Project	IEEE 802.16 Broadband Wireless Access Working Group < http://ieee802.org/16 >	
Title	Variabkle pilot boosting in uplink	
Date Submitted	2008-09-16	
Source(s)	Joerg Schaepperle, Andreas Rueegg Alcatel-Lucent	Voice: E-mail: Joerg.Schaepperle@alcatel-lucent.com * http://standards.ieee.org/faqs/affiliationFAQ.html >
Re:	SDD Session 56 Cleanup; in response to the TGM Call for Contributions and Comments 802.16m-08/033 for Session 57	
Abstract	Values for variable pilot boosting in uplink	
Purpose	Consider for inclusion into the SDD	
Notice	<i>This document does not represent the agreed views of the IEEE 802.16 Working Group or any of its subgroups. It represents only the views of the participants listed in the "Source(s)" field above. It is offered as a basis for discussion. It is not binding on the contributor(s), who reserve(s) the right to add, amend or withdraw material contained herein.</i>

Pilot Boosting in Uplink

Figure 1: Relative data SNR as a function of the pilot boosting value

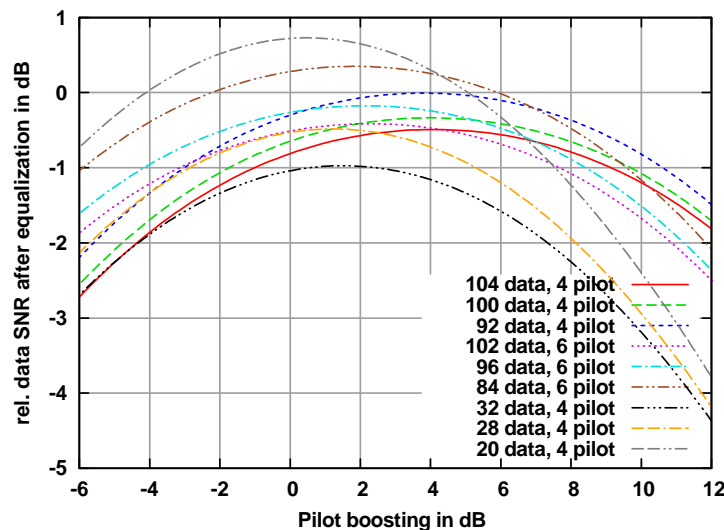
Figure shows the noise limited SNR (normalized to a constant depending on the size of the resource allocation unit) after equalization using pilots with different boosting values. It takes into account the reduction of data tone power due to increased pilot tone power (constant sum power) and the decrease in SNR due to noisy channel estimates.

From the figure we can see:

- data SNR curves have a relatively flat maximum with respect to the boosting value of the pilots
- → a step size of about 3 dB is sufficient
- reasonable boosting values for typical pilot configurations are in the range 0 dB ... 6 dB

In multi-user MIMO systems, different layers can use the same pilot pattern to save pilot overhead. This may result in interference between the pilots of the different layers. To keep the data SINR in the reasonable range, a sufficient pilot tone SINR is required. Variable pilot boosting can be used to increase pilot SINR by choosing different pilot boosting on different layers (especially, if the layers have significantly different power levels).

“The supported boosting values are: -3dB, 0 dB, 3 dB, 6 dB.”
